**ACURA** ServiceNews

BSN 16110 (9309)

**ABS Code 1-2 S/M Change**

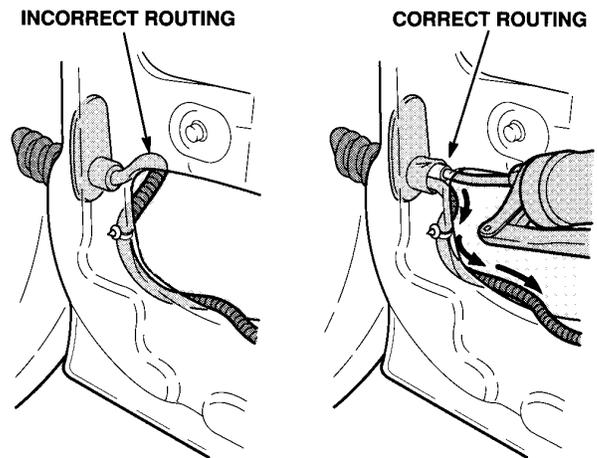
Here's a change for your 1991-93 Legend and 1992-93 Vigor S/Ms: The troubleshooting flowchart for ABS code 1-2 has you remove the 7.5 A ABS unit fuse from the under-hood ABS fuse/relay box and check for voltage between the fuse's "hot" terminal and body ground. Then the flowchart asks "Is there battery voltage?" We've measured the voltage at this terminal and found it's approximately 10 V. Change your S/Ms to read "Is there approximately 10 V?" on the following pages:

- 1991, 1992, & 1993 Legend . . . . . 19-56
- 1992 & 1993 Vigor . . . . . 19-54

**Vigor Crank Pulley Holder Attachment**

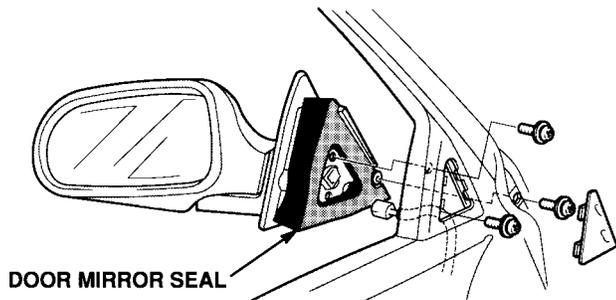
The tool number for the 50 mm Holder Attachment (for the crank pulley) on page 6-2 of the 1993 Vigor S/M was misprinted. The correct tool number is 07NAB-001040A. Also, change your copy of S/B 92-029, "Crankshaft Pulley Holder," to indicate that the 07NAB-001040A holder is now recommended instead of the 07MAB-PY3010A holder for all Vigors.
